NOTICE FOR POSTING
MEETING OF
BOARD OF ADJUSTMENT, PANEL C
MONDAY, OCTOBER 17, 2016

ZONING BOARD OF ADJUSTMENT, PANEL C
MONDAY, OCTOBER 17, 2016
AGENDA

FILE NUMBER: BDA156-098(SL)

FILE NUMBER: BDA156-105(SL)

PROJECT NUMBER
20151123
SHEET TITLE
**TREE MITIGATION
PLAN**
SHEET NUMBER
L-1.1

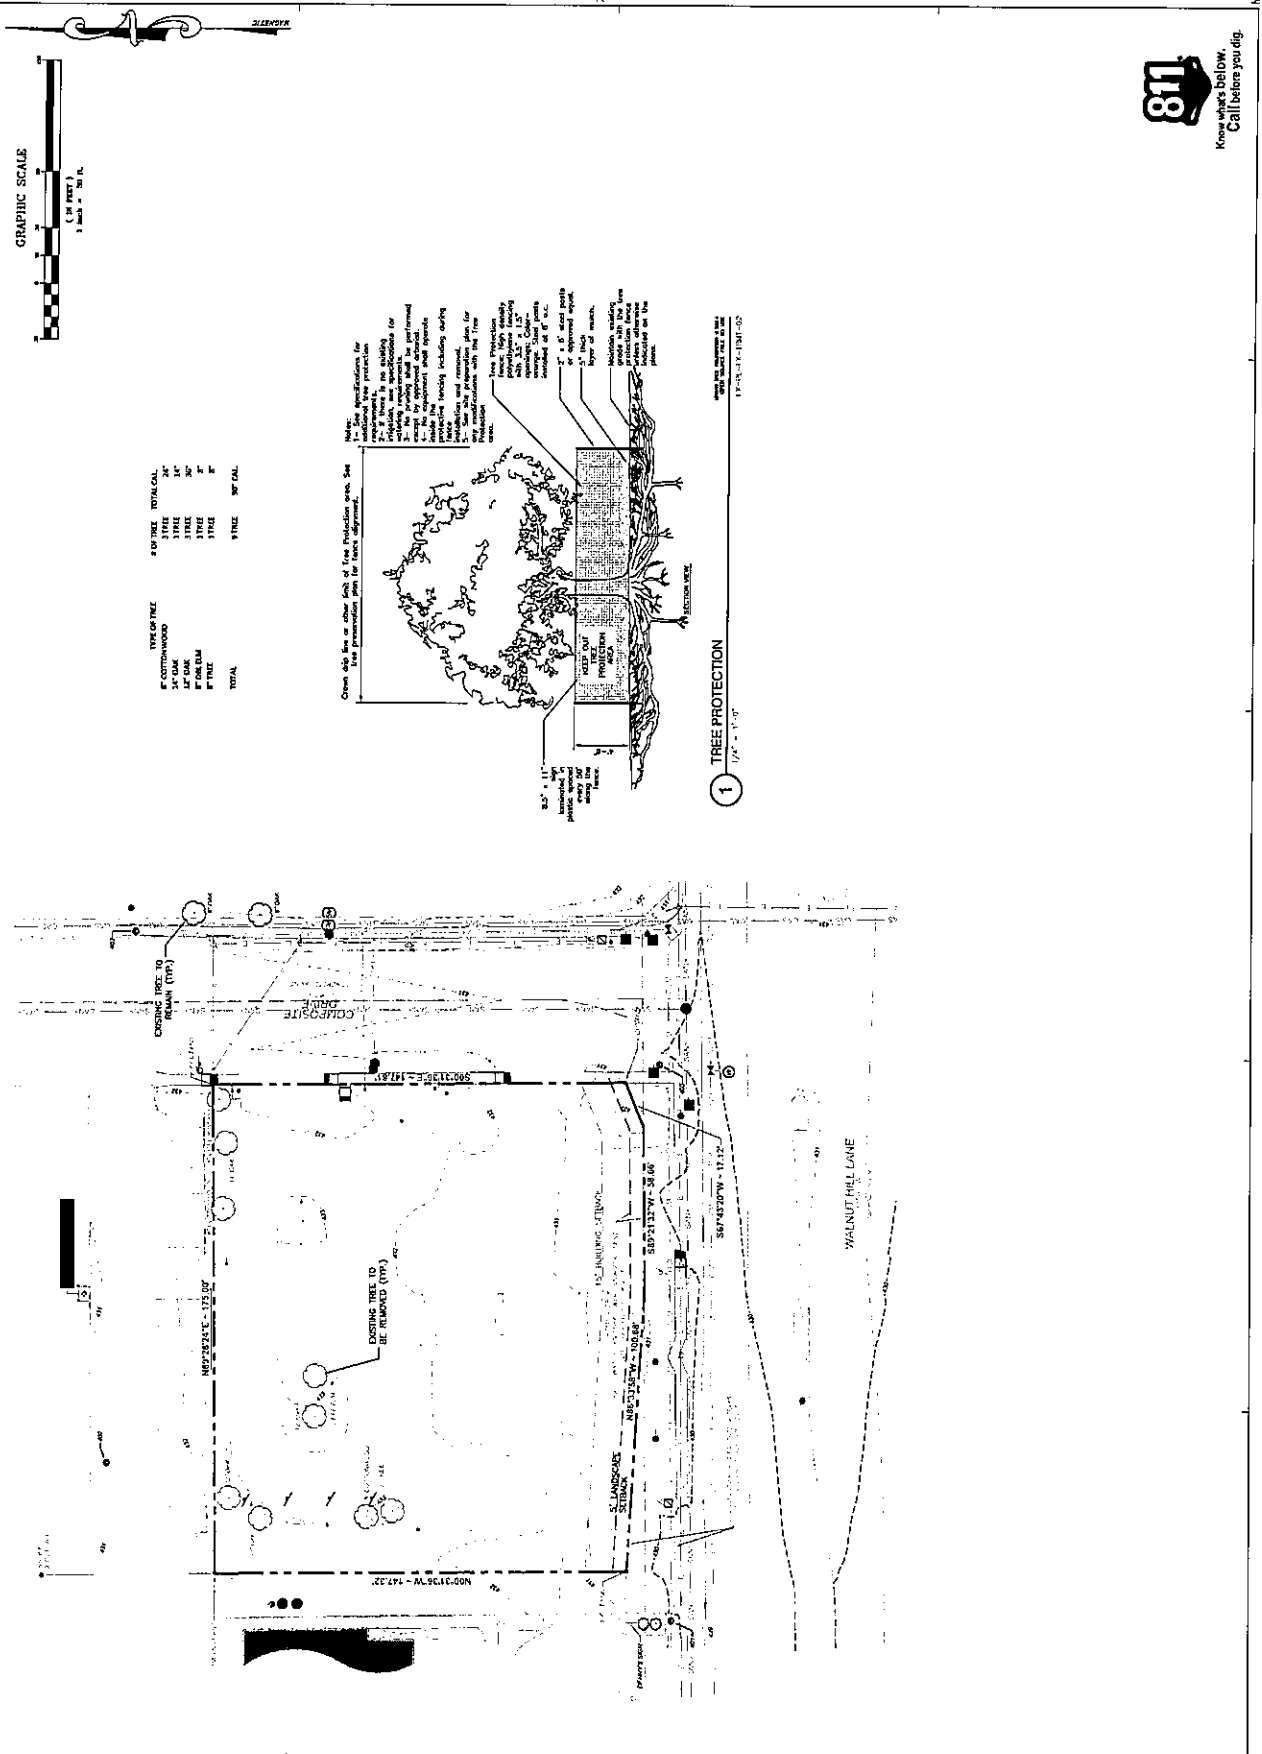
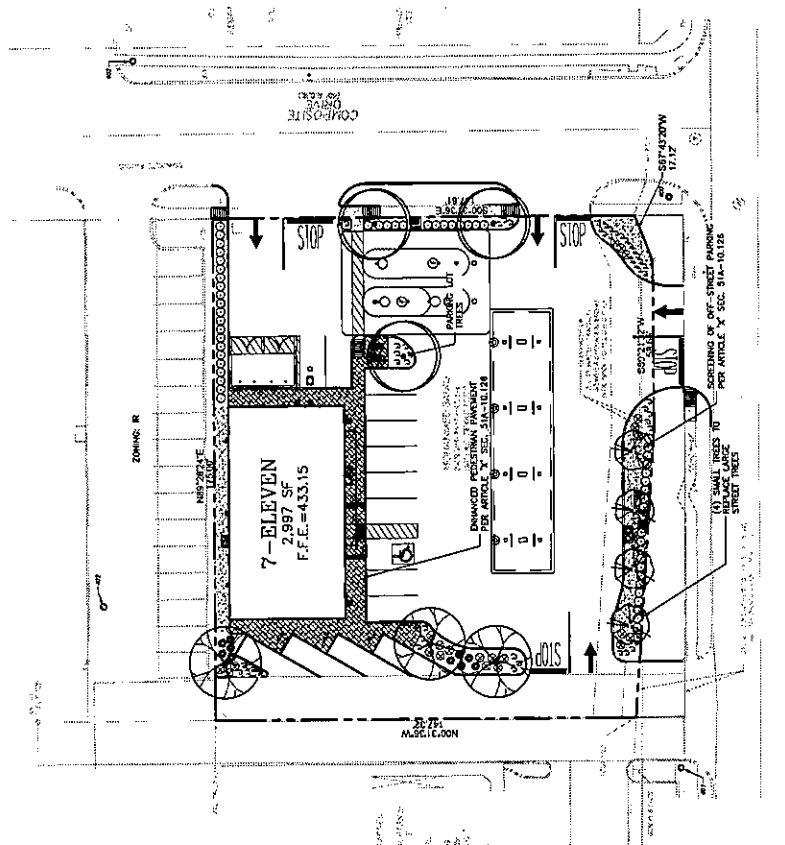
- The Chief Arborist's memo stated that the proposed alternate landscape plan is deficient in that the new project requires 7 street trees which are large species to be planted at 3" caliper whereby the plan provides 2 large street trees along Composite Drive, and 4 small trees along Walnut Hill Lane.

The new project requires 7 street trees which are large species to be planted at 3" caliper. The plan provides 2 large street trees (lacebark elm) per required specification along Composite Drive, and 4 small trees (desert willow) for Walnut Hill Lane.

The property has a portion of a 15' water, sanitary sewer & storm easement running through the southern front of the property and in the ROW to the curb along Walnut Hill. The smaller trees are provided to address the reduced available landscape area on the north side of the easement and to also keep the trees manageable for the overhead electric utility. The overall green space from interior drive to the Walnut Hill street curb will be wider than provided under the previous development.

The chief arborist recommends approval of the revised alternate landscape plan because it is my opinion that full compliance with the landscape regulations for street trees will unreasonably burden the use of the property, and the exception will not adversely affect neighboring properties.

DATE: 08/17/2016
 SHEET: SP-10
 SCALE: 1"=20'

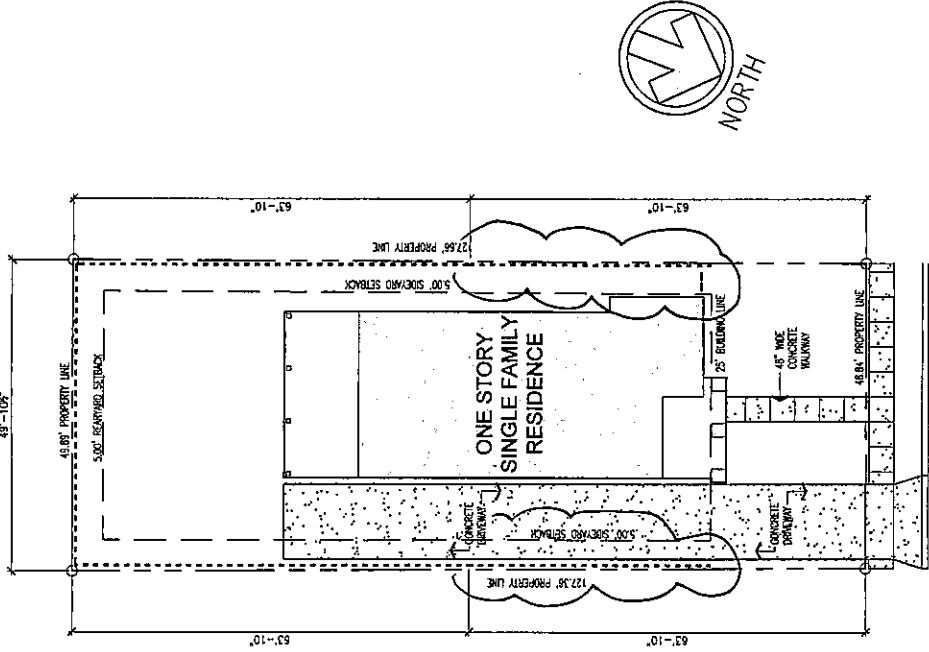
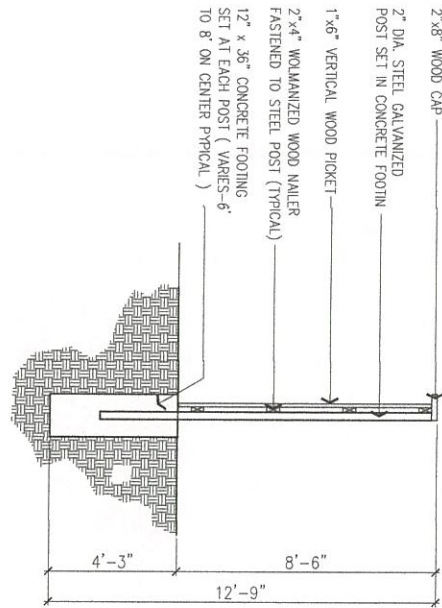
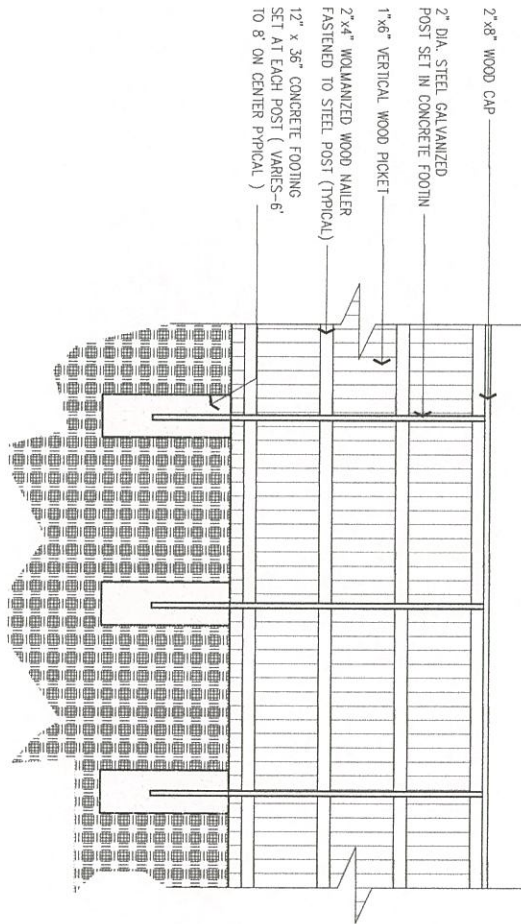
- The applicant has submitted a site plan and an elevation that indicates the proposal reaches a maximum height of 8' 6" and is located in the two, front 50 percent of the 5' side yards on the east and west sides of the subject site.

- The following additional information was gleaned from the submitted site plan:
 - The proposal is represented as being approximately 50' in length along both of the front 50 percent of the side yards on the site, and approximately 5' in length parallel to the street on the west side.

- The proposal is represented as being located on the side property lines.
- Two single family lots developed with single family structures are located on either side of the subject site. The property to the east of the subject site has a fence in its side yard that appears to be approximately 5' in height, and the property to the west has no fence in its side yard.

- The applicant has the burden of proof in establishing that the special exception to the fence height regulations of 4' 6" will not adversely affect neighboring property.
- Granting this special exception of 4' 6" with a condition imposed that the applicant complies with the submitted site plan and elevation would require the proposal exceeding 4' in height in the side yard setbacks to be maintained in the location and of the heights and materials as shown on these documents.

BDA 156-090
 Attach A
 B3

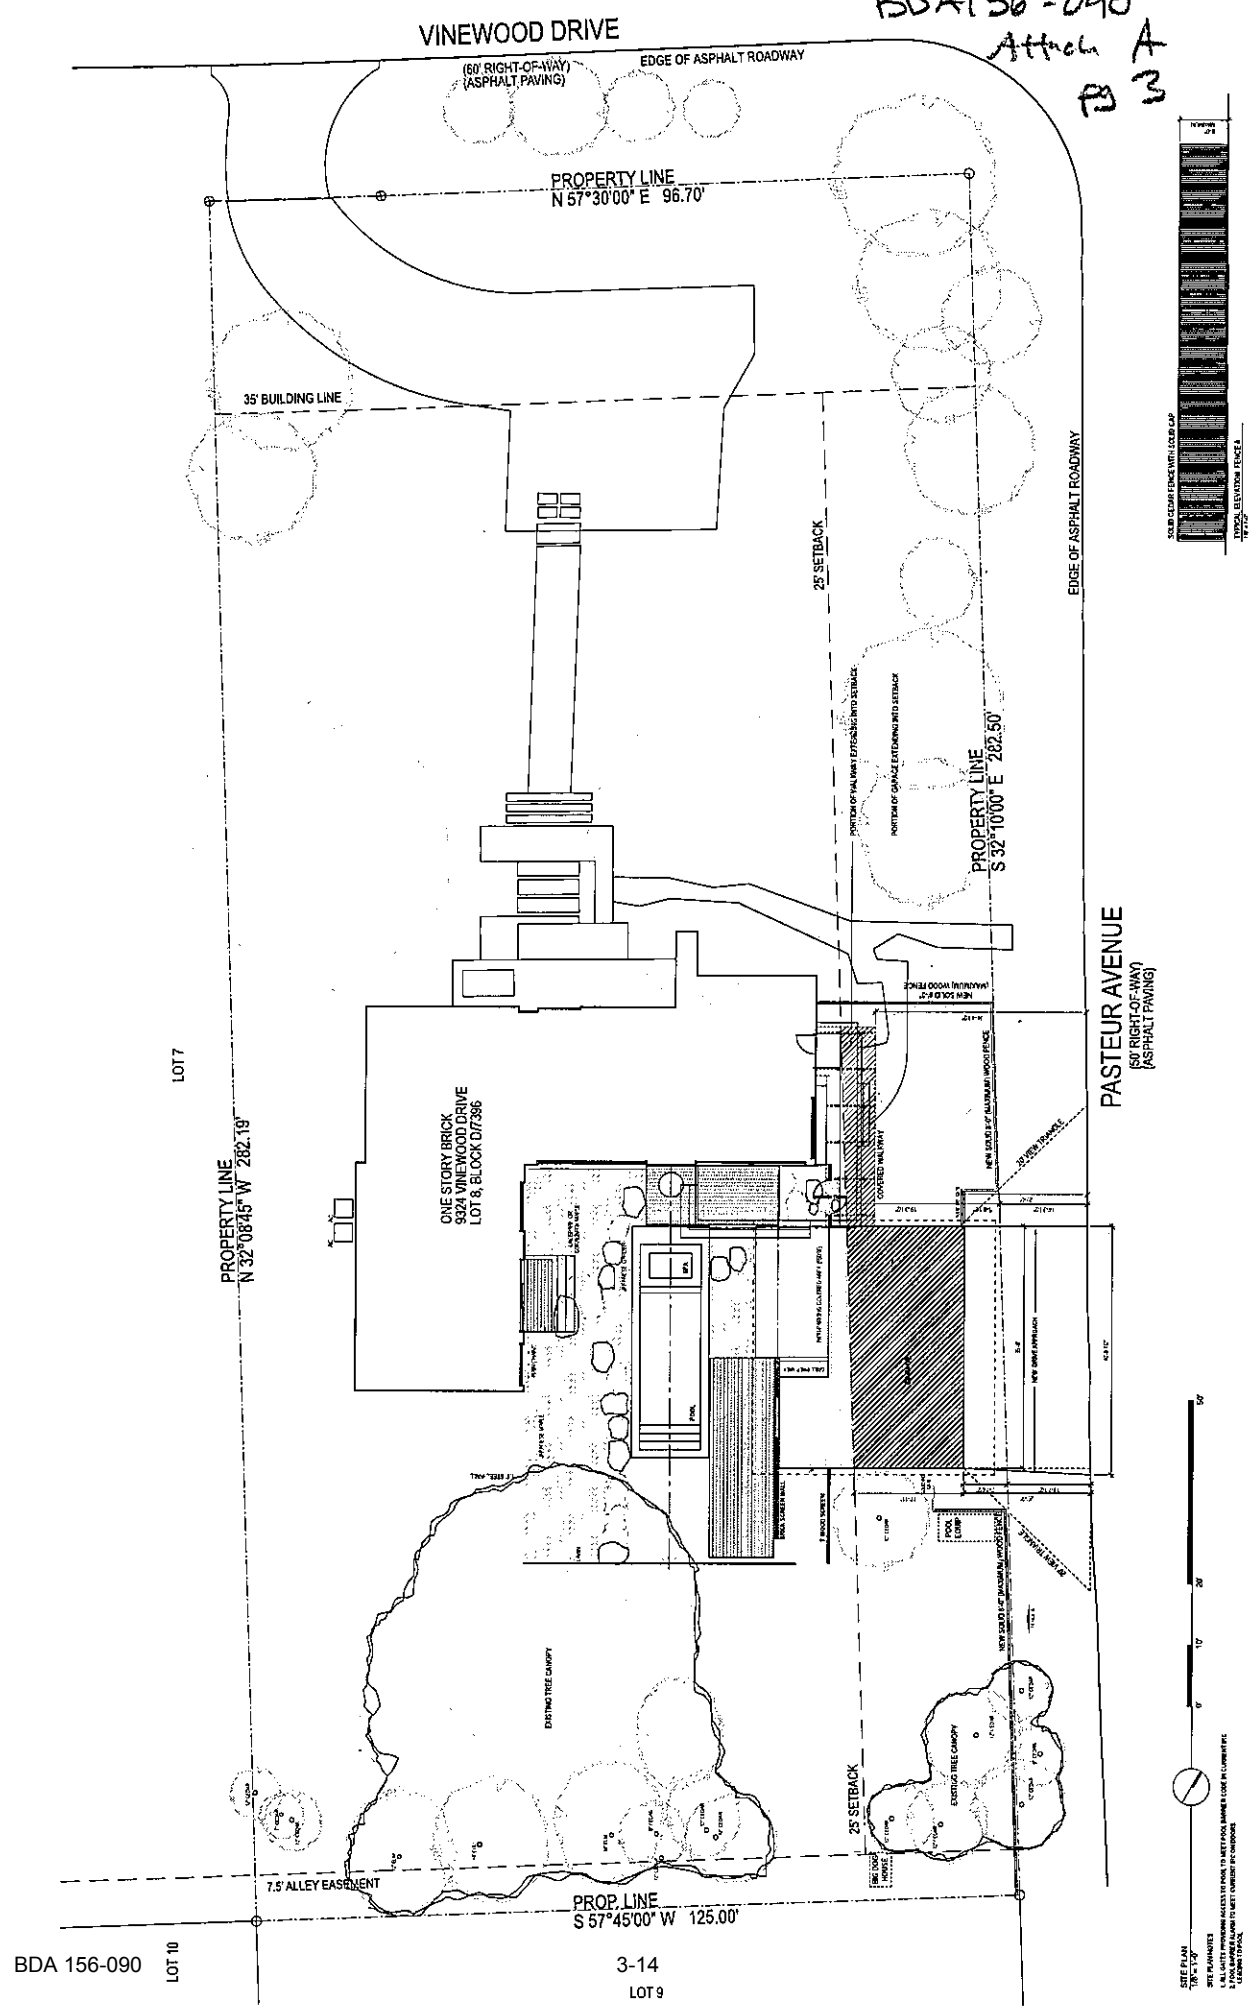
1. This plan provides a 5' 8.5" setback for the closest corner of the garage. The special exception to the 25' FY should be 19' 3.5".
2. This plan provides a 5' 8.5" setback for the enclosed parking space. The parking variance should be 14' 3.5".

Ok. Two concerns:

After reviewing the case and visiting the property, I determined that one tree, listed as a 12" cedar on the proposed site plan, is in close proximity to the south side of the proposed garage structure. This fully established and mature, single-stem eastern redcedar tree is in good condition and is worthy of preservation.

Construction activity in the large yard area further south and southwest of the proposed garage could also disrupt the extended root systems of other large mature trees identified on the site plan which I have determined to be worthy of preservation.

Please find the revised plan that provides a 20' setback from the edge of pavement. We will deliver hard copies to you ASAP.
